STATE OF NORTH CAROLINA
DEPARTMENT OF TRANSPORTATION

Subject: **Application for Modification to Section 401 Water Quality Certification** for NC 16 from north of SR 1386 in Lincoln County to North of SR 1895 in Catawba County. Federal Aid Project No. STP-F-24-1(34) State Project No. 8.1830501. TIP Project No. R-2206B/C. \$475.00 Debit from WBS Element No. 34383.1.5.

Reference: NCDENR-DWQ Water Quality Certification No. 3476 (DWQ Project No. 04-1024).

SHEET 1

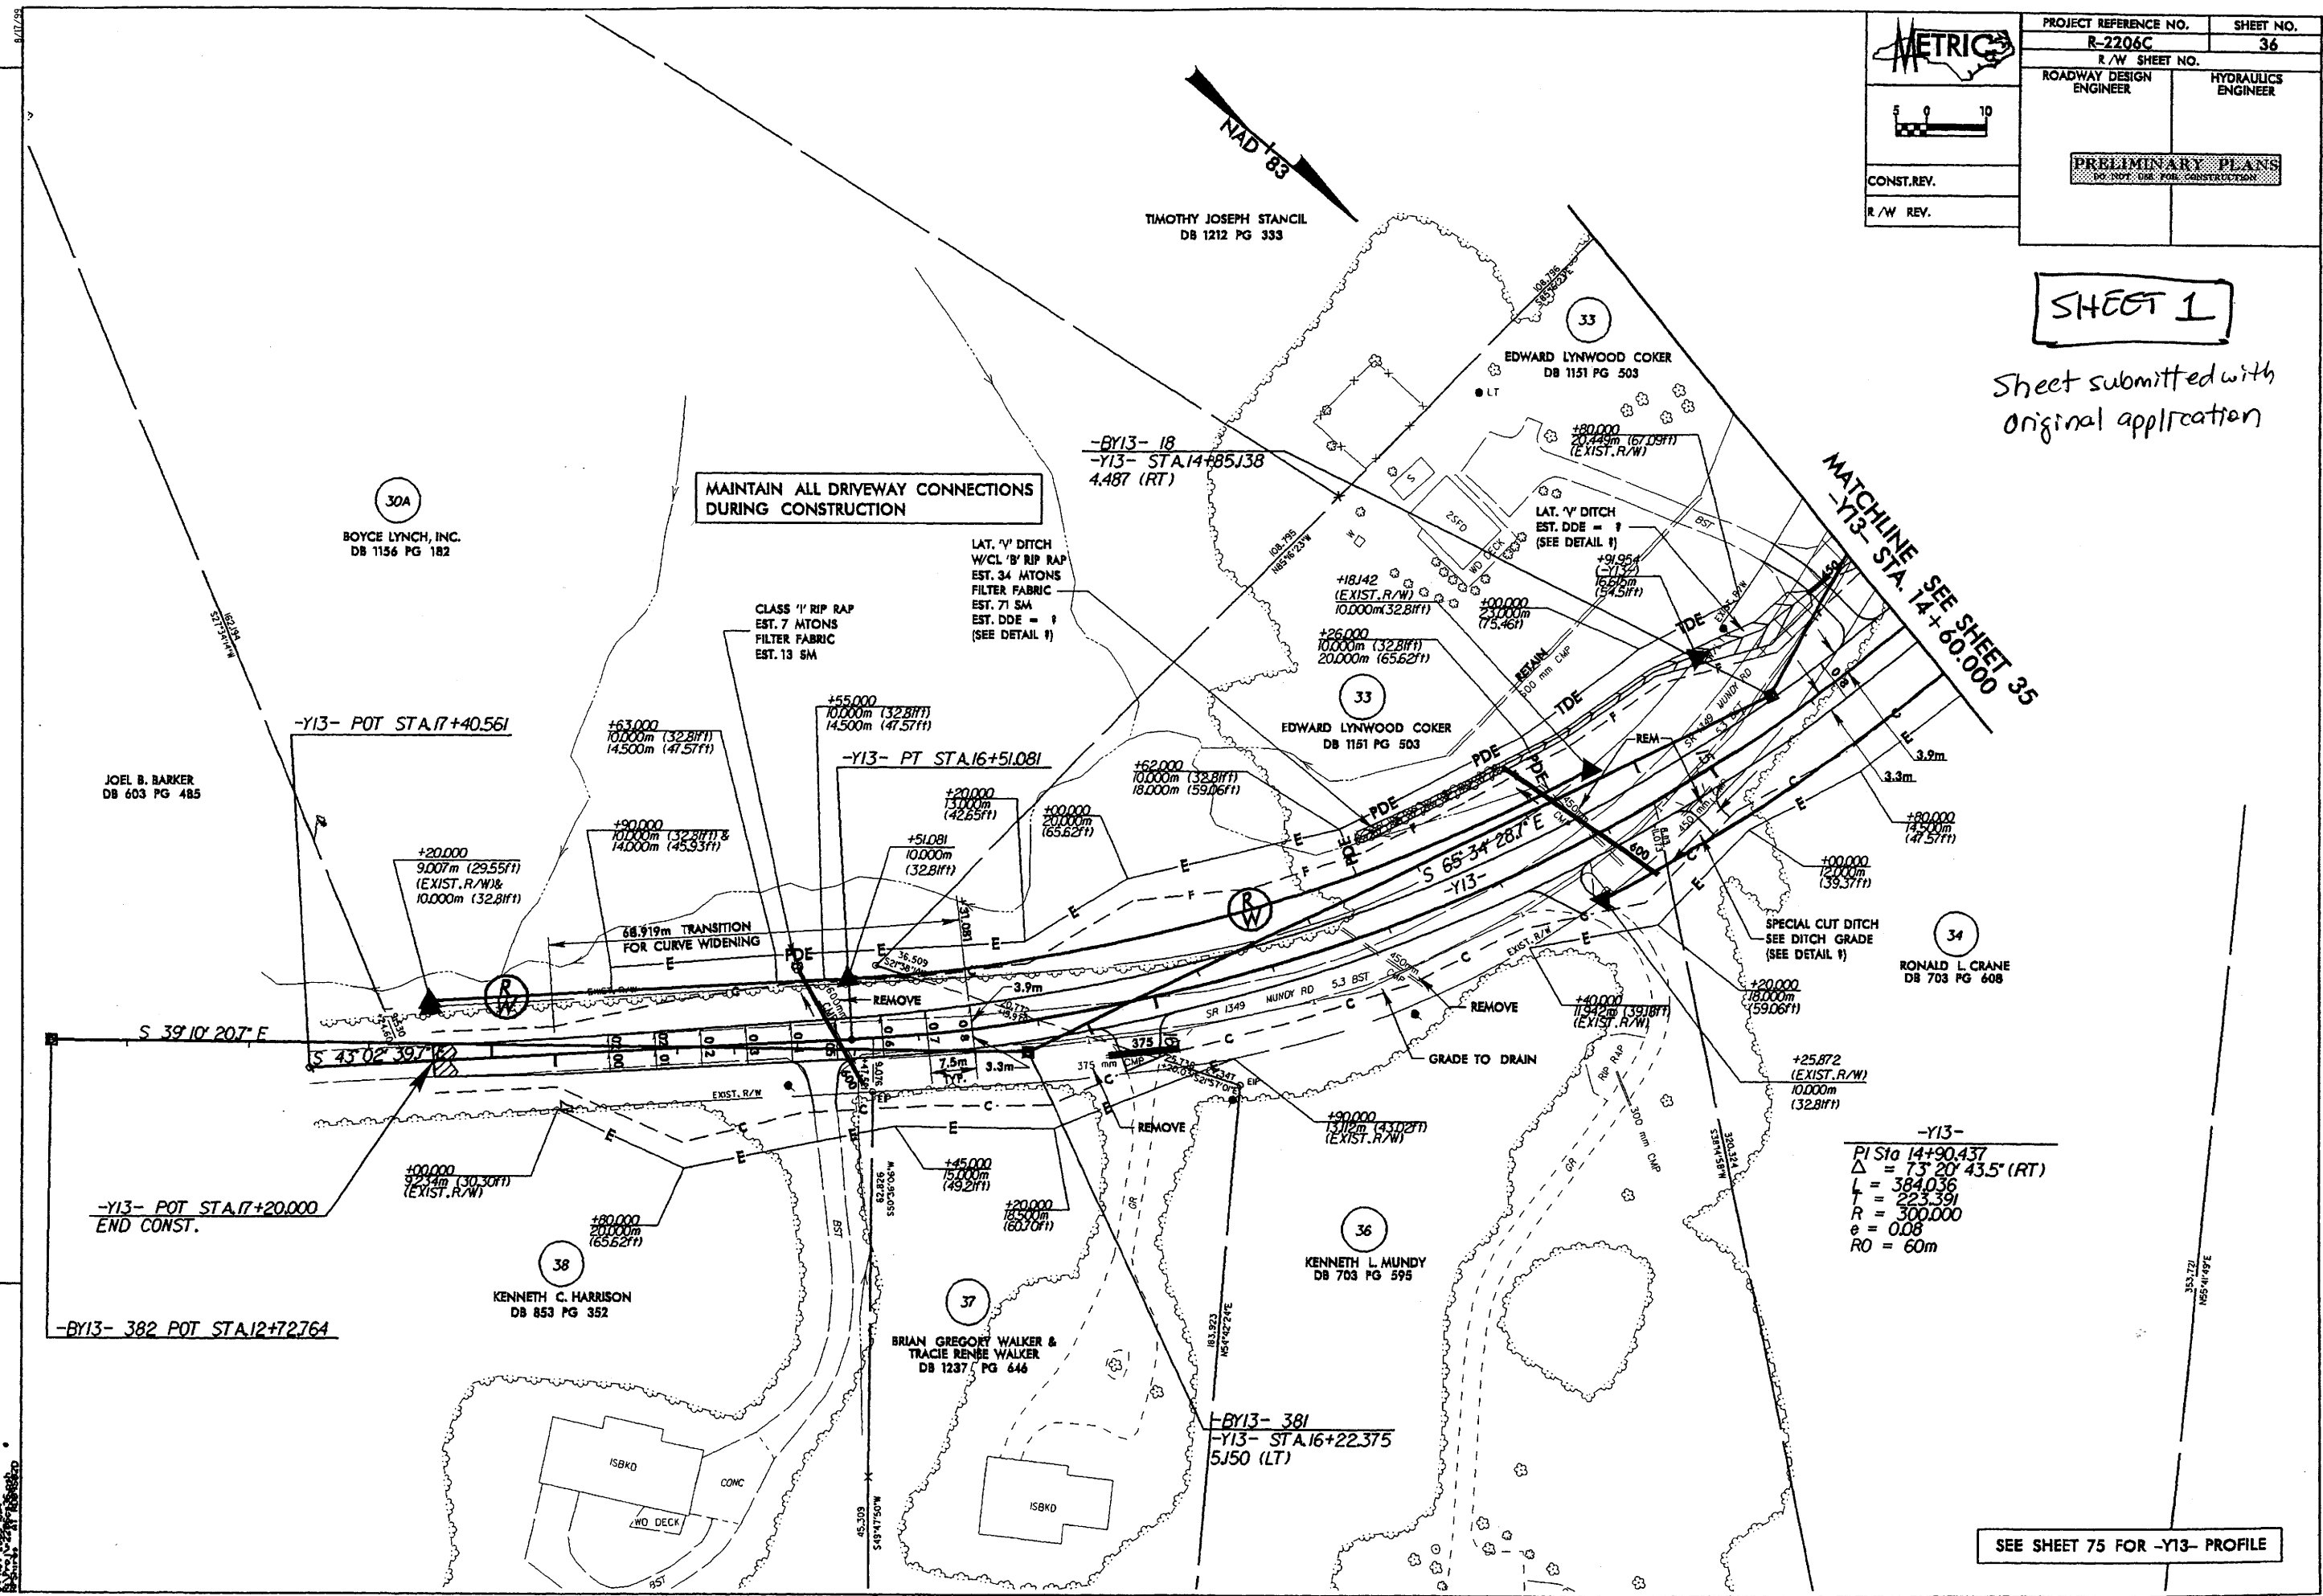
The original orientation of an unnamed tributary (UT) to Killian Creek, and the 200-foot pipe through which it flowed, were located completely outside of the fill slope of the proposed realigned Mundy Road (SR 1349), as depicted on Plan Sheet 36 of drawings submitted with the original application (Sheet 1). As such, this area had not been included as an impact site in the original application. During construction, NCDOT determined that the UT to Killian Creek did not exist as depicted on Plan Sheet 36. An adjacent property owner had removed 74 feet of the 200-foot pipe through which the UT to Killian Creek flowed, and diverted the flow to a non-jurisdictional roadside ditch located adjacent to the pre-construction orientation of Mundy Road. The diversion was via a 90-foot section of pipe that connected to the remaining 126-foot section of the original 200-foot pipe (see Sheet 2, attached).

SHEET 2

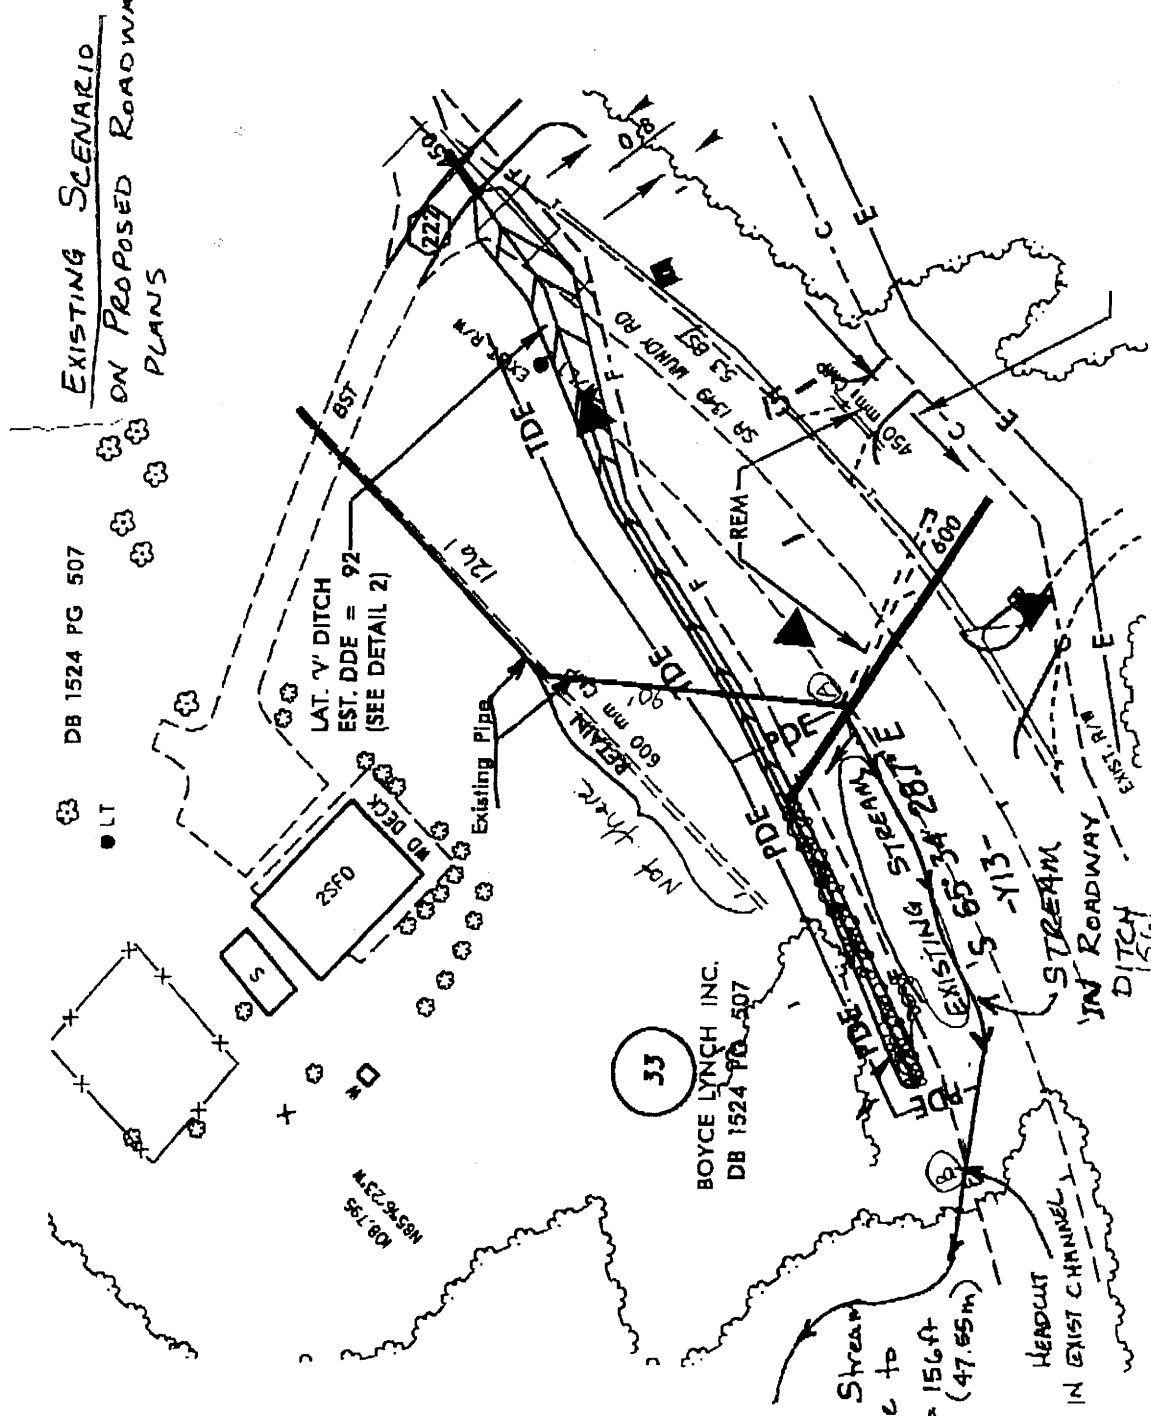
The relocated UT to Killian Creek connects downstream to its original channel, avoiding a 6+-foot headcut that formed at the end of the old ditch channel (Sheet 2). The confluence point with the stream has been armored with a rock ladder (see Sheet 3, attached) and (Sheet 4 – cross-section, attached).

SHEET 3
~~SHEET 2~~

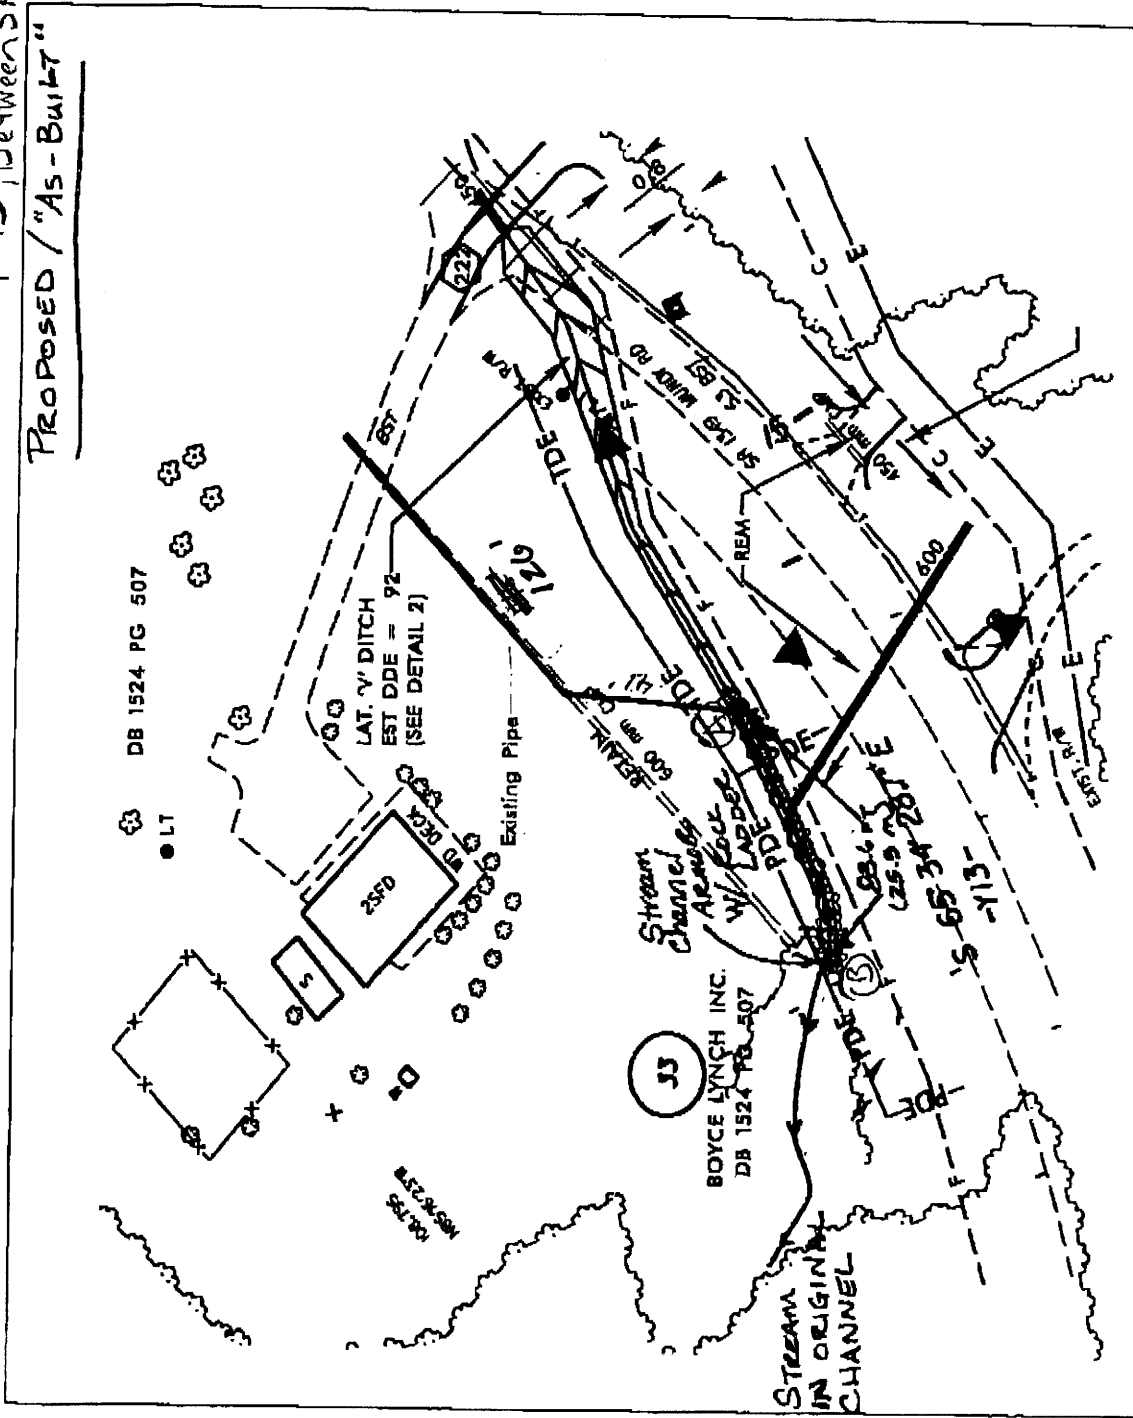
The existing ditch to which the UT to Killian Creek had been diverted was located within the proposed fill slope of the realigned Mundy Road. To address this, NCDOT relocated 156 feet of the "stream/ditch" into the newly constructed roadside ditch, located adjacent to the as-built realigned Mundy Road, and connected it to the existing 146-foot section of the original 200-foot pipe, via a 41-foot pipe (see Sheet 3, attached).
